IEEE P802.3bp (1000BASE-T1) PHY Task Force Channel Definitions Ad Hoc Report

**Kanata, CA
Sept 2014**

Revisions to IEEE P802.3bp™/D0.5 – from ad hoc reviews

Figure 97B–1

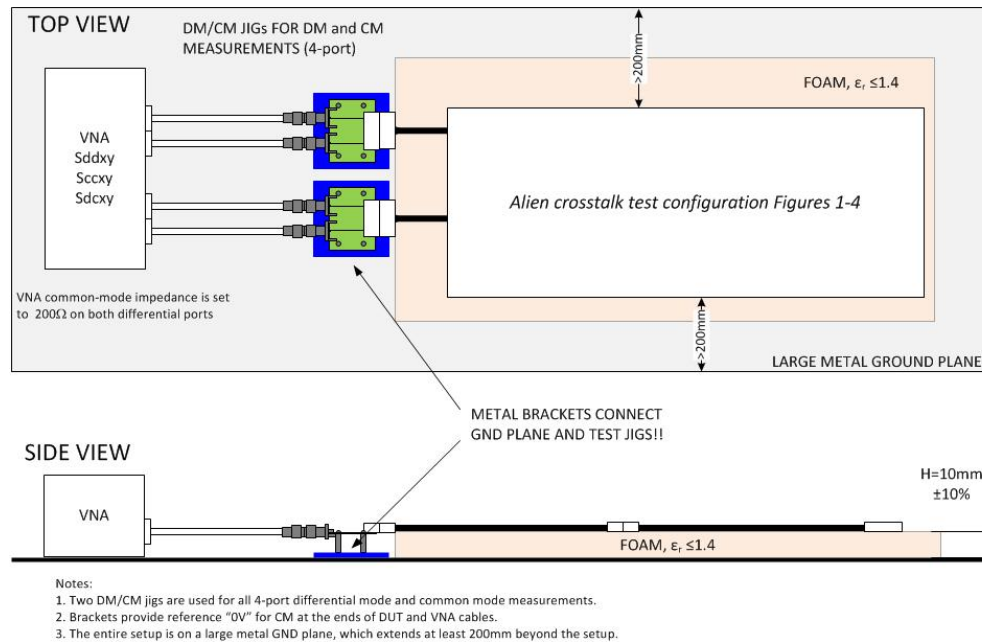
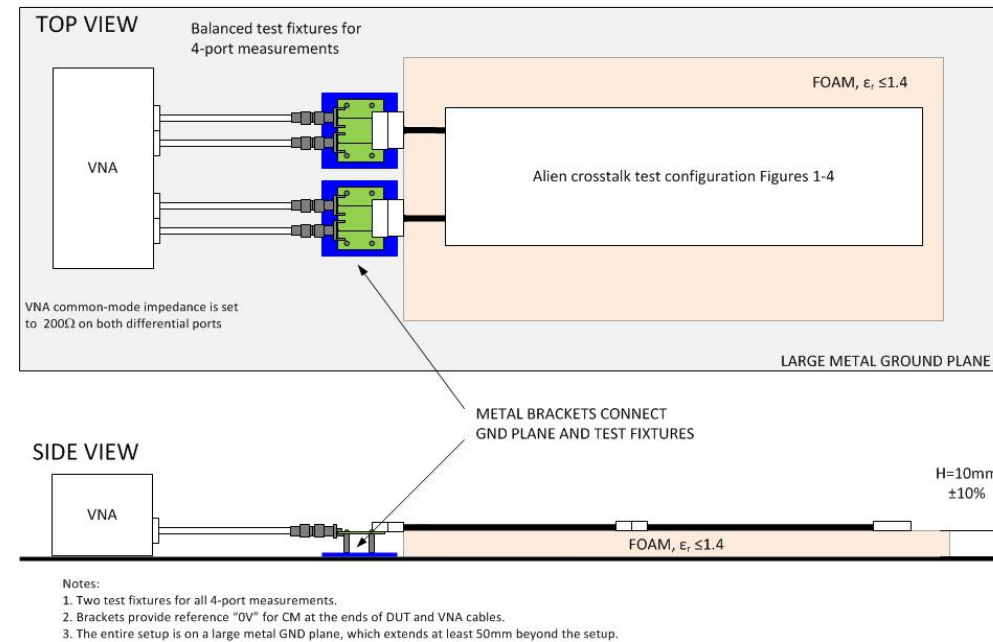
Revision Figure 97B–1

Figure 97A-1—4-port test setup

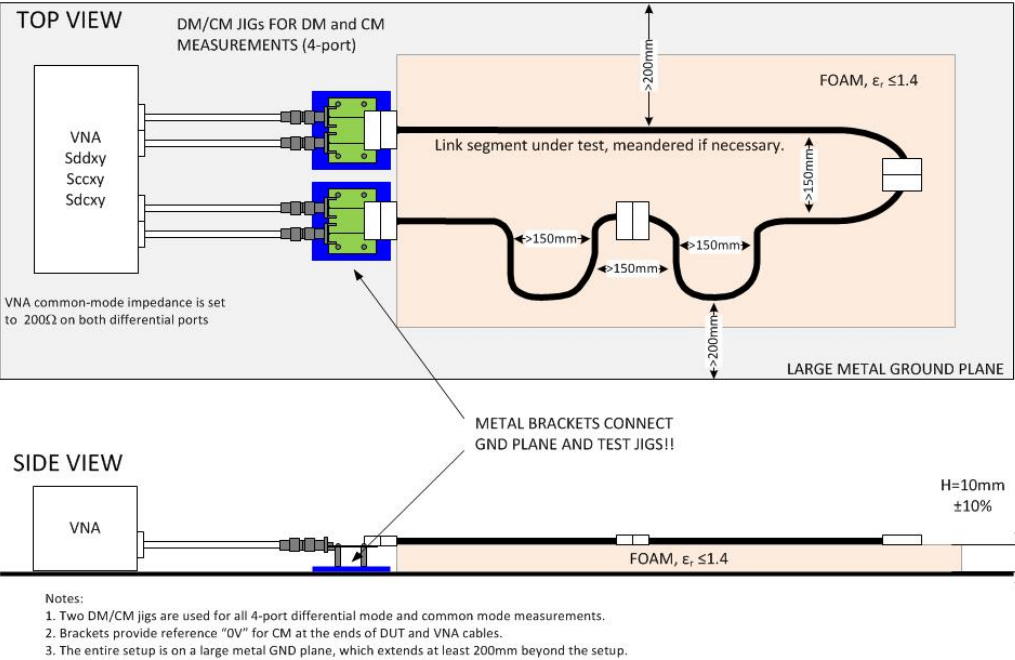
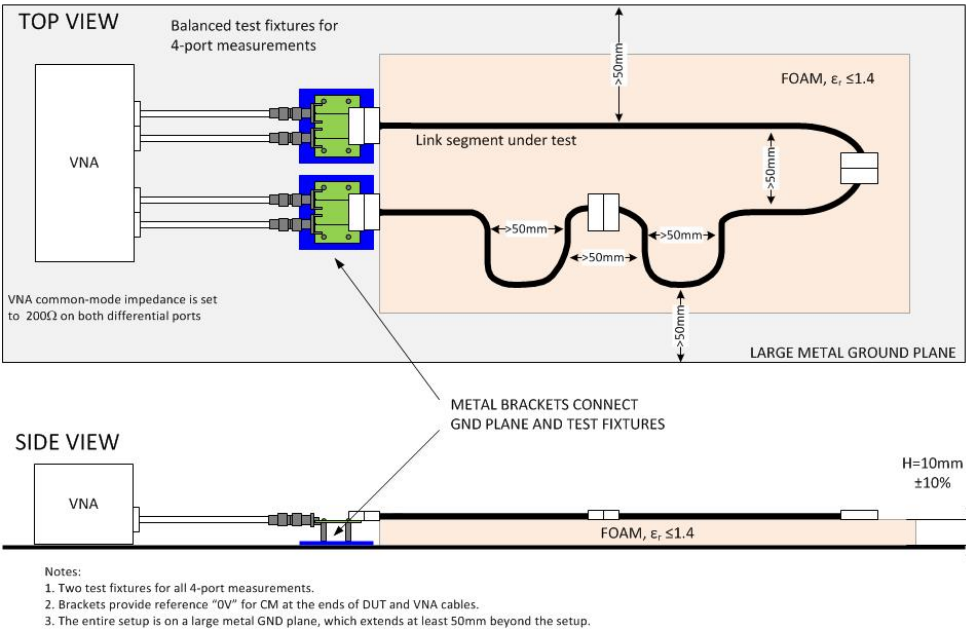
Revision Figure 97A-1—4-port test setup

Figure 97A–2—3-port common mode conversion loss measurement

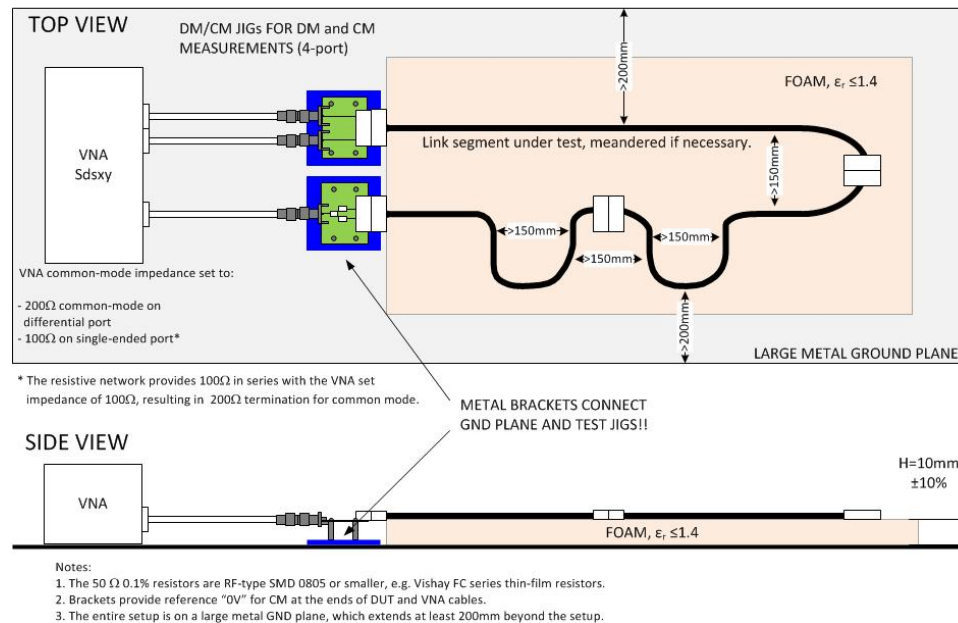
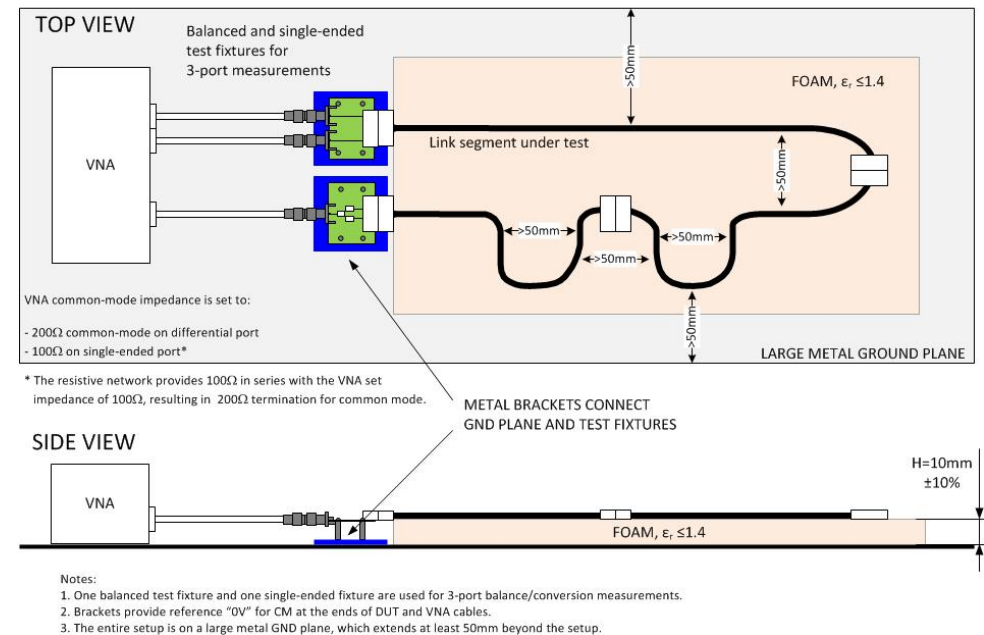
Revision: Figure 97A–2—3-port common mode conversion loss measurement

Single-ended test fixture for 3-port balance/conversion measurement

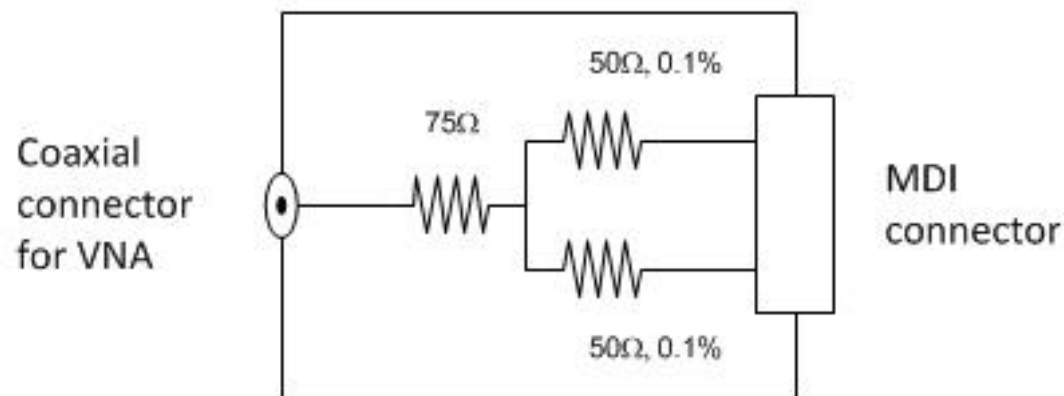
Add Figure and Equation to illustrate 66dB limit
